RE: Update to SSDR GA-1115-D-101-S

Novoste™ Corporation is requesting an update to SSDR certificate GA-1115-D-101-S to add a new design of the investigational Corona™ Delivery Catheter that is compatible with the *Model A1767 Transfer Device and AEAT SICW.2 sources.*

Image of Corona™ Delivery Catheter For Use with the A1767 Transfer Device

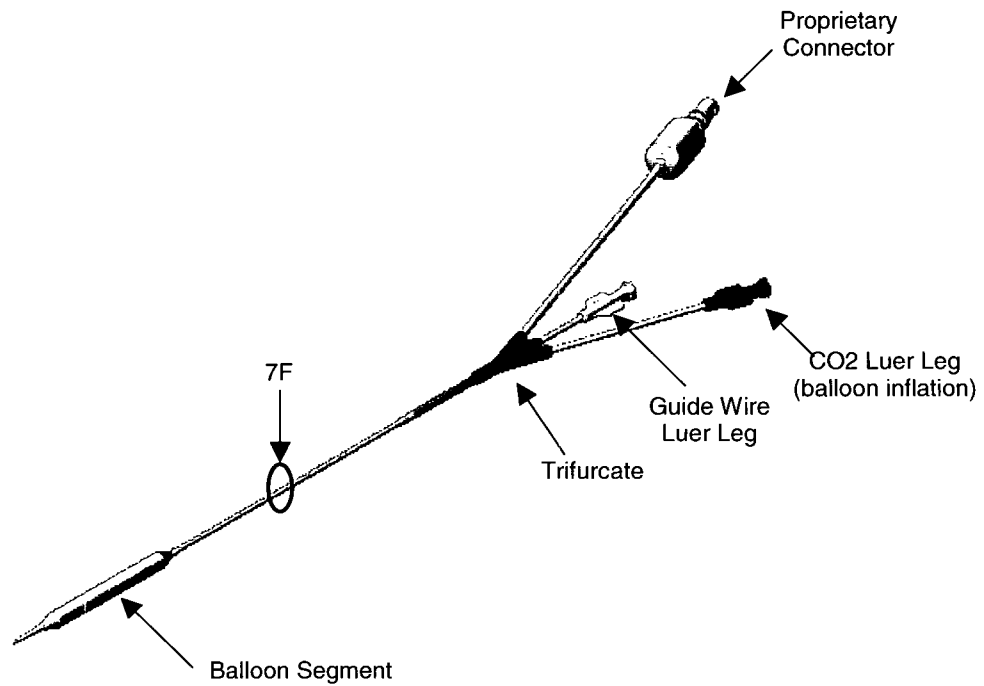
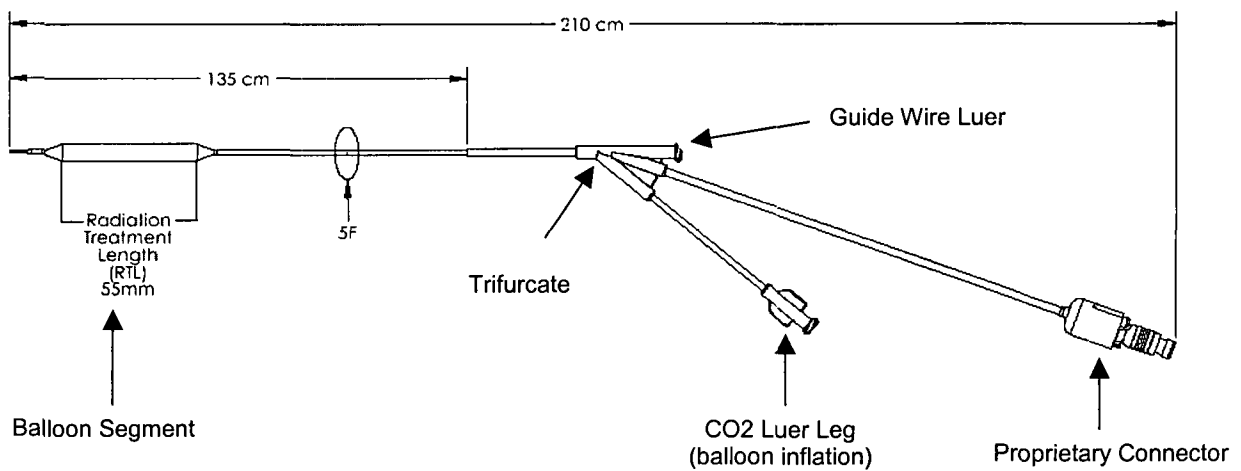
The new Corona™ System Delivery Catheter for use with the A1767 Transfer Device has a smaller 5F profile achievable with the small diameter Jacketed Radiation Source Train.

The overall length, outer diameter, source train lumen diameter and relative position of the Proprietary Connector leg, Guide Wire leg and CO₂ leg vary between the Corona™ Delivery Catheter designs, but the main shaft material (PEBAX), and four-lumen design are the same. Two images are provided on the following pages for comparison.
